SUNDRY NOTICES AND REPORTS ON WELLS (DO NOT USE THIS FORM FOR PROPOSALS TO DRILL OR TO DEEPEN OR PLUG BACK TO A DIFFERENT RESERVOIR. USE "APPLICATION FOR PERMIT" (FORM C-101) FOR SUCH PROPOSALS.) 1. Type of Well: Oil Well <input checked="" type="checkbox"/> Gas Well <input type="checkbox"/> Other <input type="checkbox"/>		WELL API NO. 30-025-32042 5. Indicate Type of Lease STATE <input checked="" type="checkbox"/> FEE <input type="checkbox"/> 6. State Oil & Gas Lease No.

2. Name of Operator BXP OPERATING, LLC		7. Lease Name or Unit Agreement Name CAPROCK MALJAMAR UNIT 8. Well Number 152
3. Address of Operator 1515 West Calle Sur. St, Suite 174, NM 88240		9. OGRID Number 329487 10. Pool name or Wildcat [43329] MALJAMAR; GRAYBURG-SAN ANDRES

CAPROCK MALJAMAR UNIT #152**1355' FSL & 1351' FWL, UL K Sec 17, T17S, R33E, Lea County, New Mexico**

**CONDITIONS OF APPROVAL
FOR PLUGGING AND ABANDONMENT
OCD - Southern District**

Spud Date: **4" diameter 4' tall Above Ground Marker**

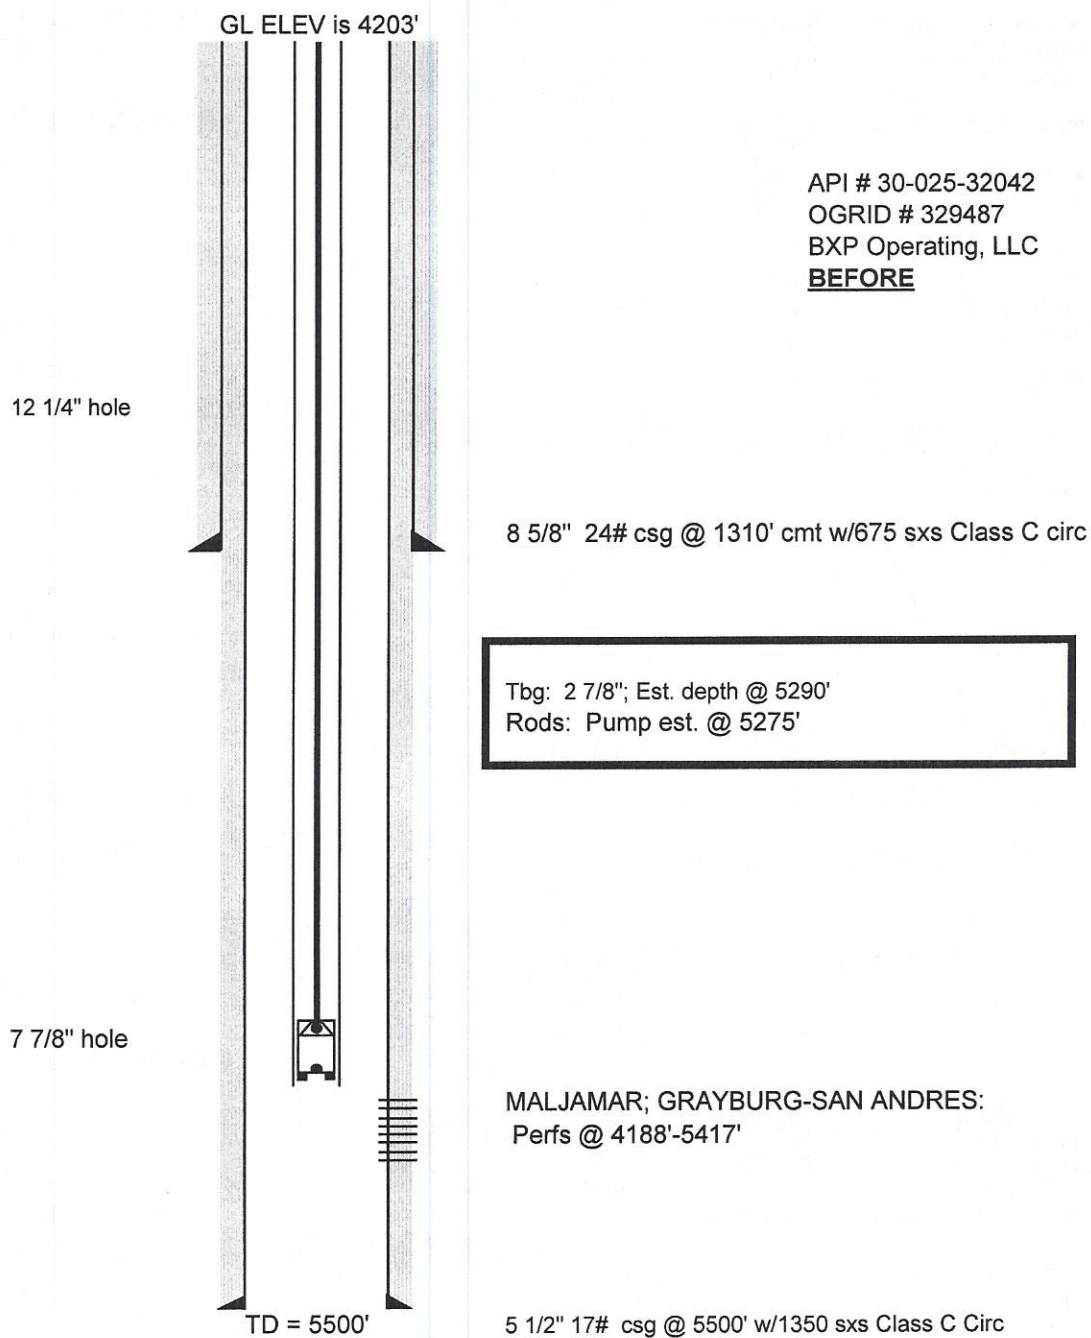
Rig Release Date: **SEE ATTACHED CONDITIONS OF APPROVAL**
